Work Order ID 163196

Item Name: Fwd.Crosstube - High 407

DRAWING NO. D407-667-145	TITLE CROSSTUBE ASS'Y (407 HIGH FWD)	REV. C	DART AEROSPACE LTD ENGINEERING ORDER		D.E.O. NO. D407-667-145-C-1	SHEET NO. SHEET 1 OF 1	SCALE NTS
DRAWN <i>q</i>	CHECKED <i>ASS</i>	MFG. APPR. <i>182</i>	APPROVED <i>WD</i>		DE APPR. <i>#</i>		
DATE 11.07.15	DATE 11.07.22	DATE 11.07.22	DATE 11/07/22		DATE 11.07.21

DRAWING NO. D407-667-145	TITLE CROSSTUBE ASS'Y (407 HIGH FWD)	REV. C	DART AEROSPACE LTD ENGINEERING ORDER	D.E.O. NO. D407-667-145-C-2	SHEET NO. SHEET 1 OF 1	SCALE NTS
DRAWN AJS	CHECKED <i>[Signature]</i>	MFG. APPR. <i>[Signature]</i>	APPROVED <i>[Signature]</i>	DE APPR. <i>[Signature]</i>		
DATE 12.08.02	DATE 12.08.02	DATE 12.08.02	DATE 12.08.02	DATE 12.08.02	DATE 12.08.02

ADD ELECTRICAL GROUNDING STRAP

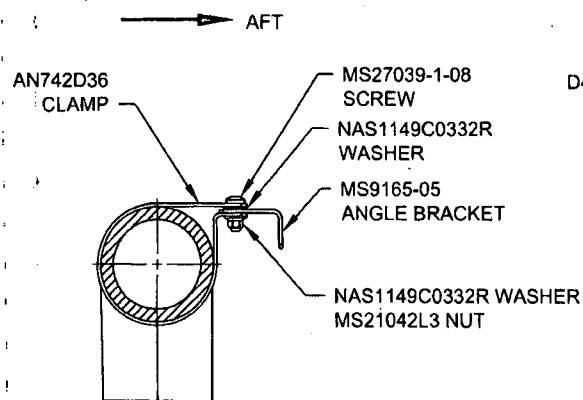
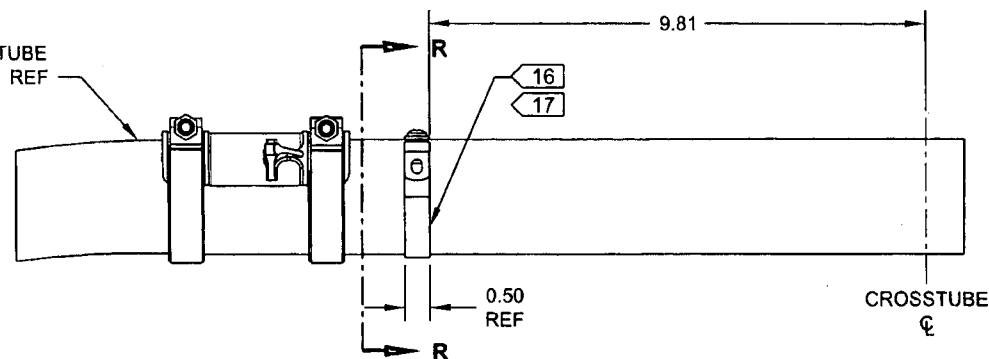
— ADD

— ADD
